BROOKHAVEN NATIONAL LABORATORY
ASSOCIATED UNIVERSITIES, INC.

SUBJECT: Memorandum: "BNL Peer Review of the Zion Probabilistic Safety Study", A. J. Buslik to R. A. Bari, 1/18/82 (Enclosure 1).

Memorandum: "On the Two-Stage Bayesian Procedure for Determining Plant-Specific Frequencies for Initiating Events", I. A. Papazoglou to R. A. Bari, 1/19/82 (Enclosure 2).

DATE: January 18, 1982 (Typographical errors corrected January 22, 1982)
TO: R. A. Bari
FROM: A. J. Buslik *AJB*
SUBJECT: BNL Peer Review of the Zion Probabilistic Safety Study

Frequency of Loss of Offsite Power, λ (per reactor year)
(Scholl - Data)

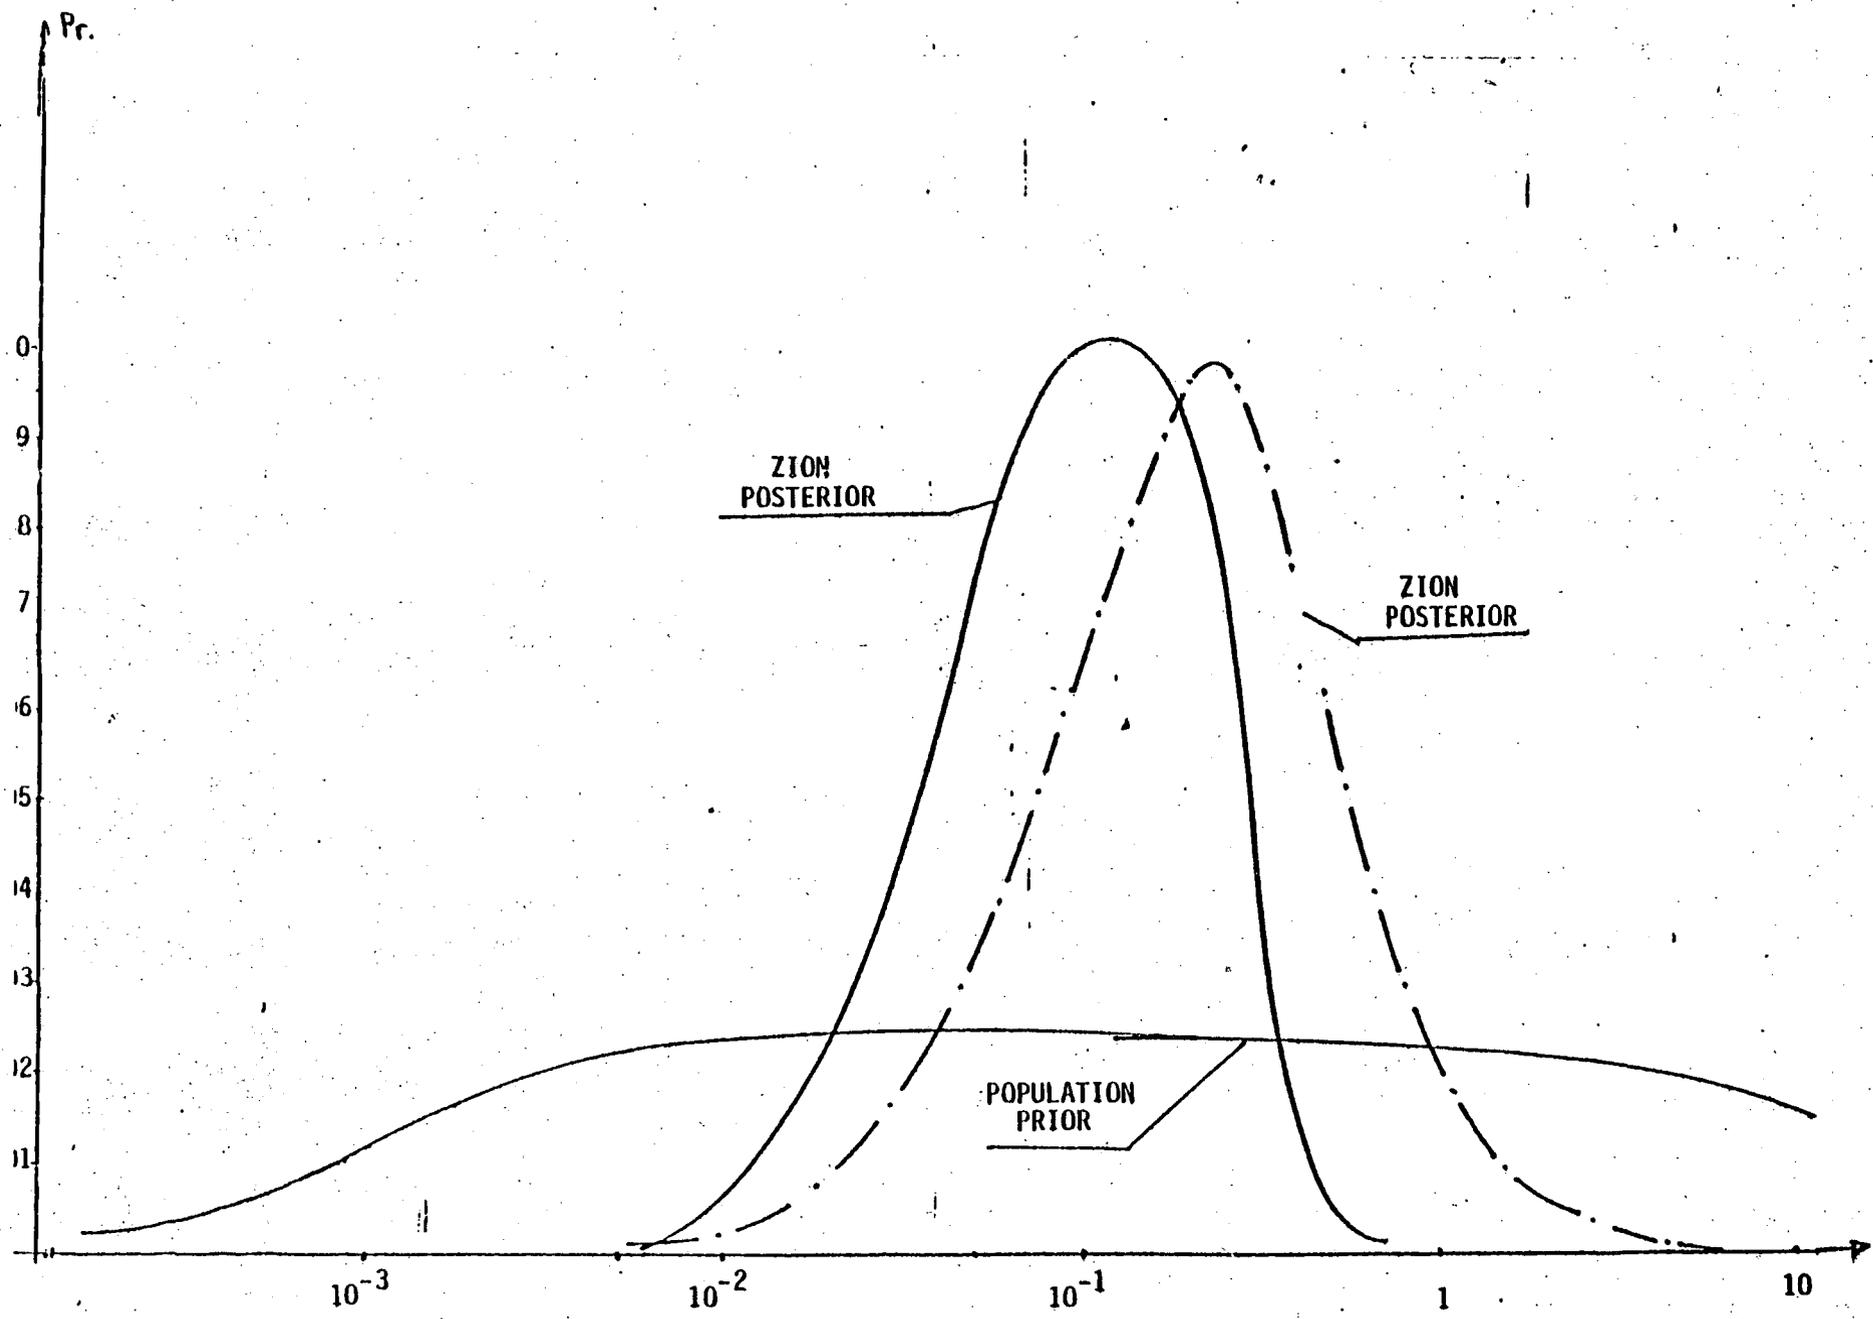
Applying the procedure outlined above to the data given in Table 3, the results of Table 6 are obtained. It is noteworthy that for this set of data (Ref. 5) the differences between the BNL and Zion PRA procedures are indeed insignificant. The differences between the BNL estimates and the ones given in the Zion PRA are rather significant and are due to the difference in the data presented in References 4 and 5. The figure shows the population prior, population posterior, and Zion posterior pdf is for λ .
